# UNITED STATES PATENT AND TRADEMARK OFFICE

APPLICATION NO.	FILING DATE	FIRST NAMED INVENTOR	ATTORNEY DOCKET NO.	CONFIRMATION NO.
10/785,209	02/24/2004	Ronald P. Hohmann JR.	PHO-236 CIP	8805
48745	7590	10/06/2008		
SILBER & FRIDMAN 1037 ROUTE 46 EAST SUITE 207 CLIFTON, NJ 07013			EXAMINER FIGUEROA, ADRIANA	
			ART UNIT 3633	PAPER NUMBER
			MAIL DATE 10/06/2008	DELIVERY MODE PAPER

### Office Action Summary

Hohmann (US 4,598,518)

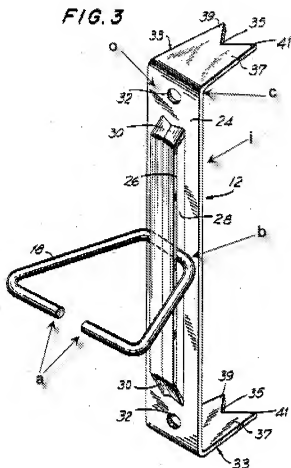
Regarding claim 1, Hohmann discloses a surface-mounted anchoring system for use in the construction of a wall having an inner wythe (19) and an outer wythe (20), said outer wythe formed from a plurality of successive courses (22) with a bed joint between each two adjacent courses, said inner wythe and said outer wythe in a spaced apart relationship the one with the other forming a cavity therebetween, said inner wythe having an exterior layer being insulation (17), (Figures 1, 2), said surface-mounted anchoring system comprising: an anchoring system having a wall anchor (12) constructed from a plate-like body (24) having two major faces being the mounting surface (i) and the outer surface (o), said wall anchor, in turn, comprising; a pair of legs (33), each extending from said mounting surface of said plate-like body from an inboard location thereof with the longitudinal axis of each of said legs being substantially normal to said mounting surface (i), (annotated Figure 3), said legs adapted for insertion at a predetermined insertion point into said exterior layer of said inner wythe,

a covering portion (c) formed at said mounting surface (i) of said plate-like body, said covering portion adapted to preclude penetration of air, moisture and water vapor into said exterior layer, (annotated Figure 3);

an apertured receptor portion (28) adjacent said outer surface (o) of said plate-like body (24), (annotated Figure 3), said aperture receptor portion adapted to limit displacement of said outer wythe toward and away from said inner wythe;

a veneer tie (18) threadedly disposed through said apertured receptor portion (28) , (annotated Figure 3) of said wall anchor and adapted for embedment in said bed joint of said outer wythe to prevent disengagement from said anchoring system.

Regarding claim 7, Hohmann modified by Stephens discloses the claimed invention; Hohmann further teaches an attachment portion (a) for threading through said apertured receptors (28); an insertion portion (b) contiguous with and opposite said attachment portion, said insertion portion being swaged for interconnection with said reinforcement wire, (annotated Figure 3);

In response to applicant's argument that Hohmann '518 does not teach "a covering portion". Examiner asserts that the portion (c) indicated in the annotated Figure 3 would create a cover portion between the leg and the inner surface of the body.
